Project	IEEE 802.16 Broadband Wireless Access Working Group < http://ieee802.org/16 >	
Title	Comment on Unsolicited RNG-RSP in transparent RS System	
Date Submitted	2007-07-05	
Source(s)	Kanchei (Ken) Loa, Yi-Hsueh Tsai, Yung-Ting Lee, Hua-Chiang Yin, Shiann-Tsong Sheu, Youn-Tai Lee,	Voice: +886-2-27399616 Fax: +886-2-23782328 loa@iii.org.tw
	Institute for Information Industry 8F, No. 218, Sec. 2, Dunhua S. Rd., Taipei City 106, Taiwan	
Re:	IEEE 802.16j-07/019: "Call for Technical Comments Regarding IEEE Project 802.16j"	
Abstract	This contribution proposes the modified figures of MS unsolicited RNG-RSP in non-transparent RS system under centralized scheduling scheme based on comment #1141 of 80216j-07_014r4.cmt.	
Purpose	Text proposal for 802.16j Baseline Document.	
Notice	<i>This document does not represent the agreed views of the IEEE 802.16 Working Group or any of its subgroups. It represents only the views of the participants listed in the "Source(s)" field above. It is offered as a basis for discussion. It is not binding on the contributor(s), who reserve(s) the right to add, amend or withdraw material contained herein.</i>

Comment on Unsolicited RNG-RSP in transparent RS Sy

Figure 108f—Unsolicited RNG-RSP ~~in Transparent RS system~~ triggered by upstream traffic at Transparent Access RS

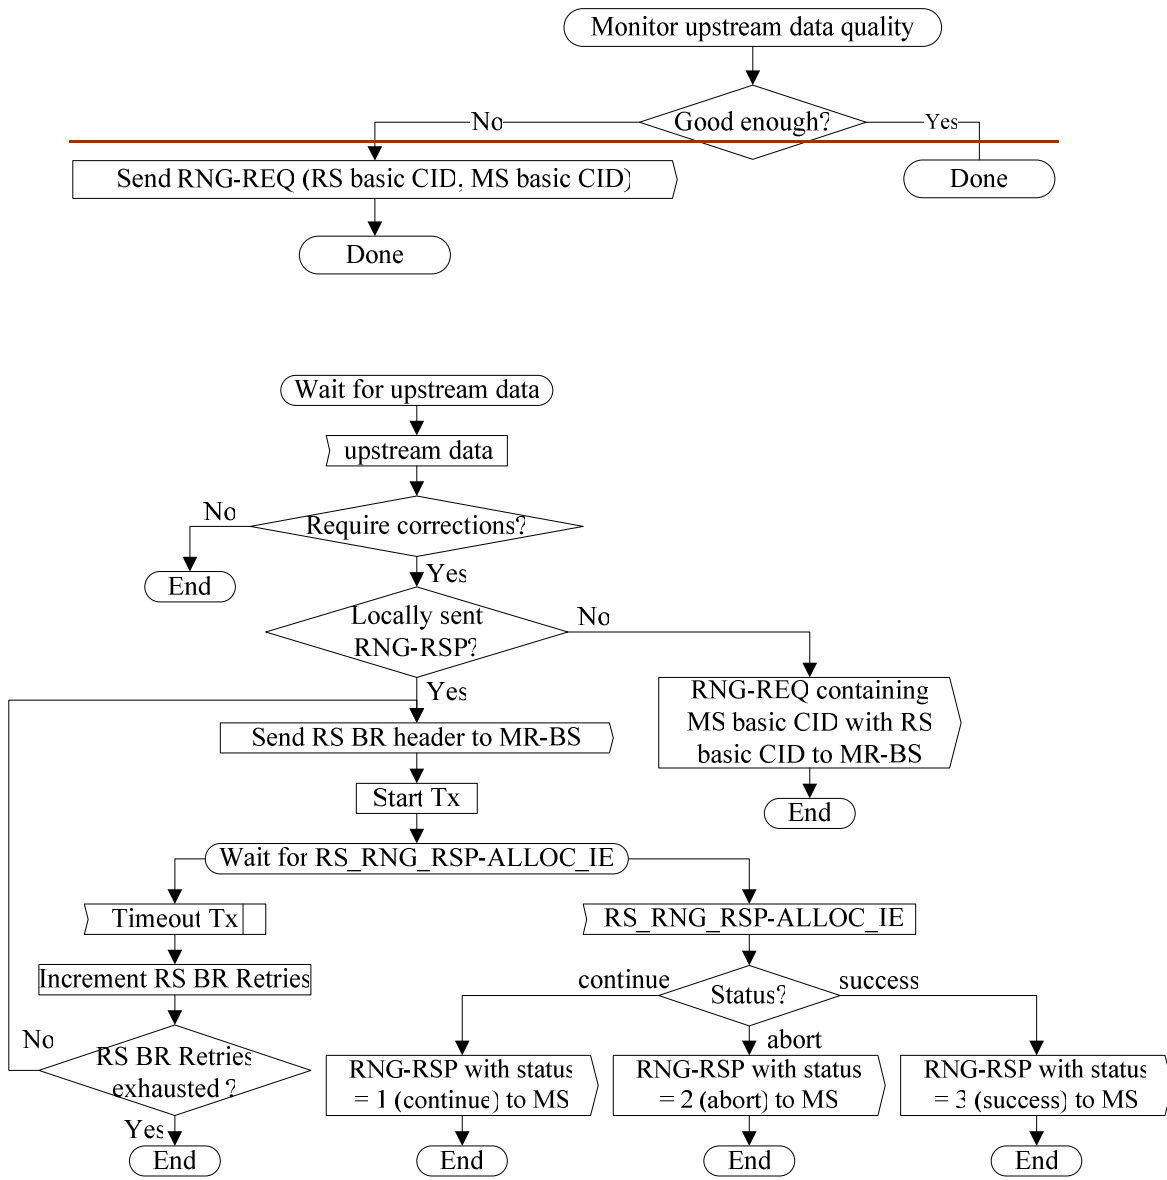
When the offsets of frequency, power, and timing for any other data transmission from the MS are beyond the tolerance defined in this specification, RSs shall either transmit a RNG-REQ message with the RS basic CID containing the MS basic CID to the serving MR-BS through the relay path, or locally send an unsolicited RNG-RSP to MS in optional transparent zone. In order to send RNG-RSP to MS in optional transparent zone, RS shall send a RS BR header to MR-BS.

[Replace the following Figure 108g in page 99 as indicated]

Figure 108g ~~Unsolicited RNG-RSP in Transparent RS system~~ Handle RNG-REQ in transparent mode at MR-BS

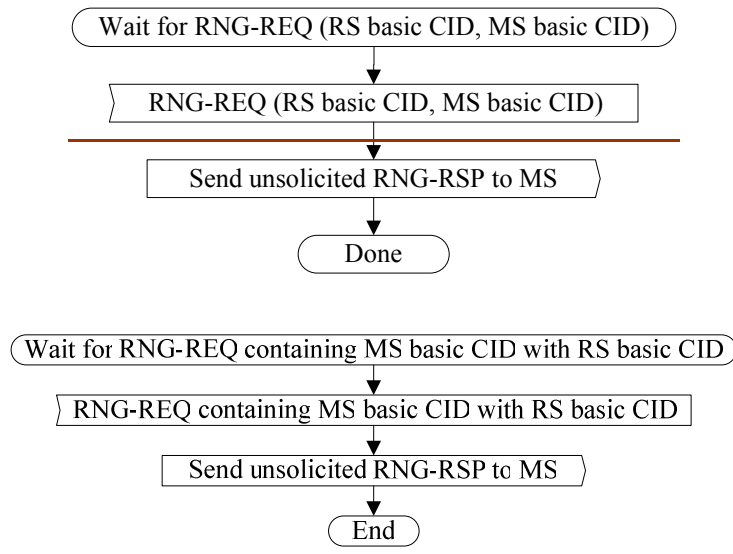
[Replace the following Figure 108h in page 99 as indicated]

Figure 108h ~~Unsolicited RNG-RSP triggered by CDMA BR ranging code in Transparent RS system at~~ Transparent Access RS

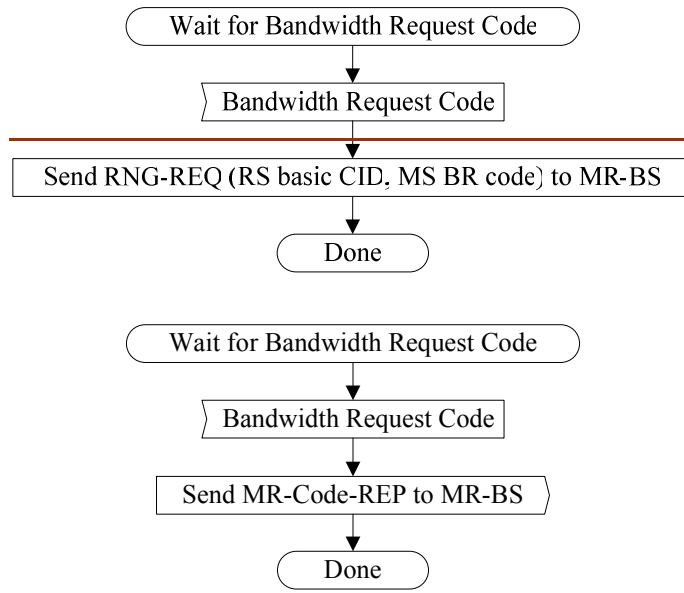
After RS receives a bandwidth request CDMA ranging code, it should transmit an ~~RNG-REQ~~ MR-Code-REP message with the RS basic CID containing the CDMA BR ranging code to the serving MR-BS through the relay path with adjustment information of frequency, power, and timing corrections. When RS receives multiple codes in the ranging subchannel of a frame, the ~~RNG-REQ~~ MR-Code-REP message sent by the RS to serving MR-BS may contain information of multiple received codes.

[Replace the following Figure 108i in page 99 as indicated]

Figure 108i Unsolicited RNG-RSP triggered by CDMA BR ranging code in Transparent-RS system mode at MR-BS

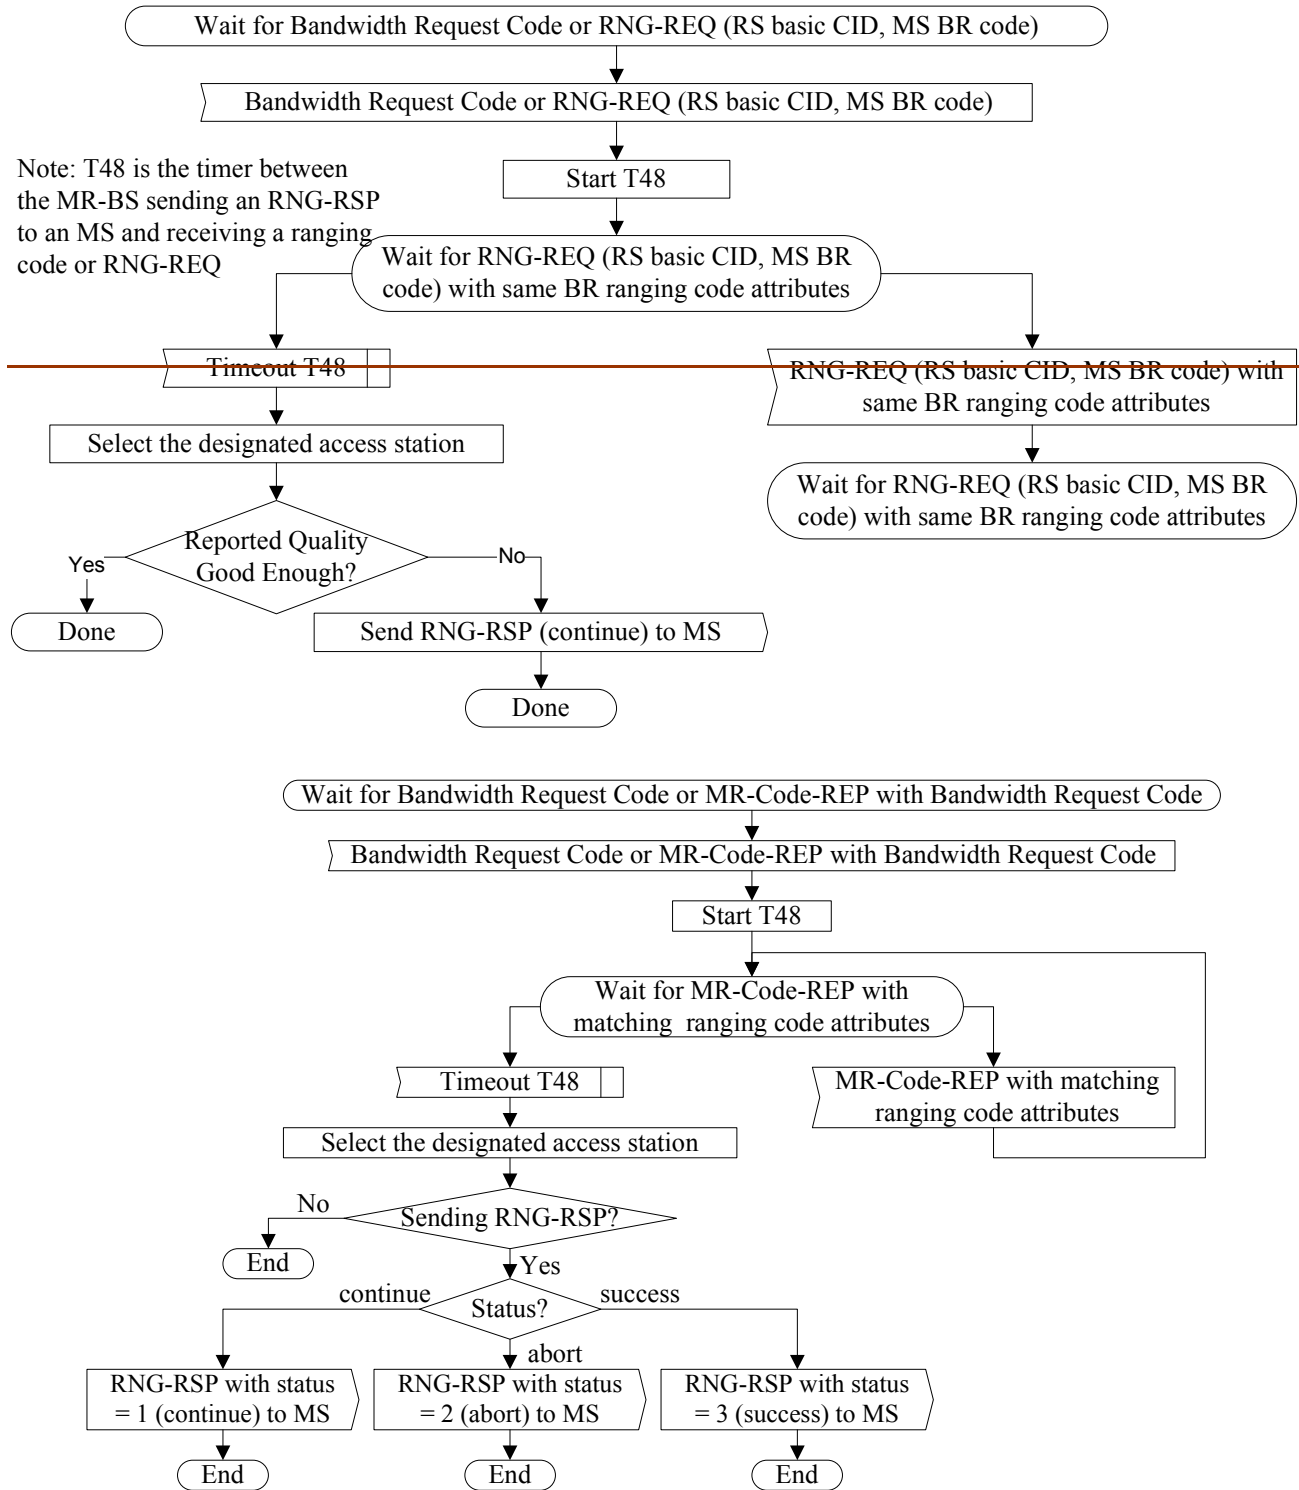
When the MR-BS receives a bandwidth request CDMA ranging code, it shall wait for ~~RNG-REQ~~ MR-Code-REP with the same ranging code from its subordinate RSs for T48 timer.
